LIGHTNING F MK. 2

LIST OF LETTERED ADDENDA  
(EJECTION SEAT MK. 4BSA)

## Addendum A

## (Introduction of downward pull negative-G restraining strap)

## (5) Fig.3. Arrangement of negative-G restraining strap on P.S.P Disregard Fig. 3 in Chapter 2 and refer to Fig. 1 of this addendum.

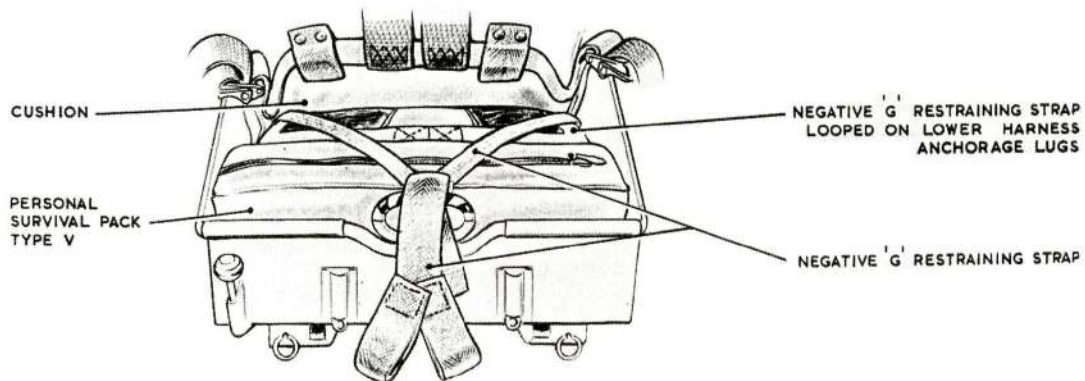
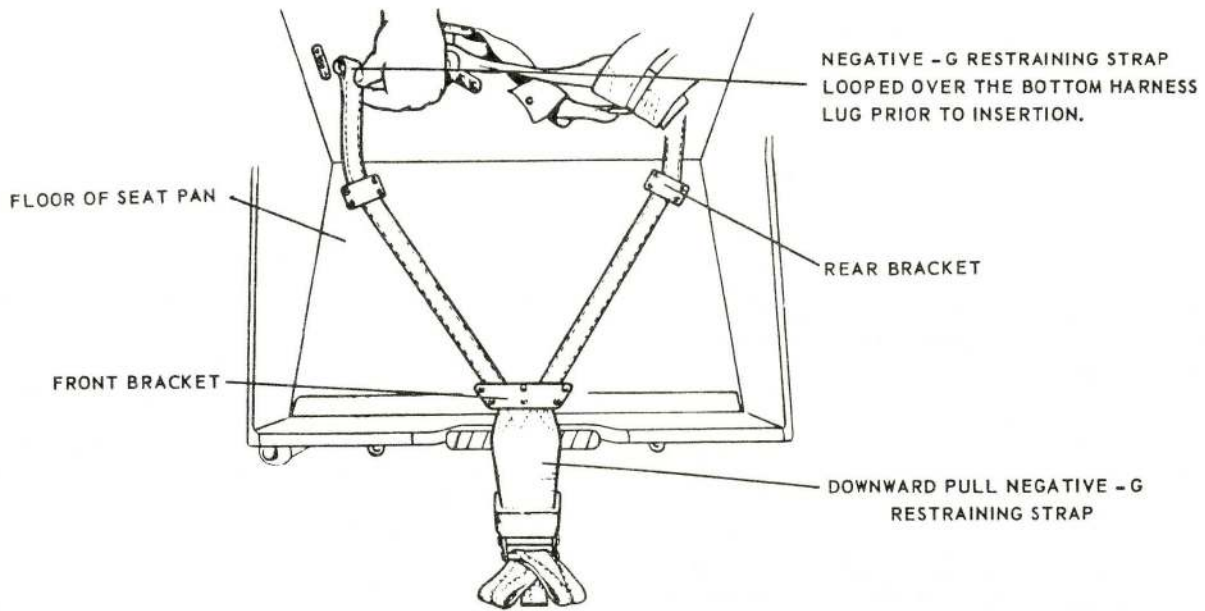
1 Modification E.S. 2690 introduces a downward pull negative-G restraint strap in lieu of the upward pull strap introduced by modification P.A. 69.

Fig. 1 Arrangement of downward pull negative-G restraining strap in seat pan
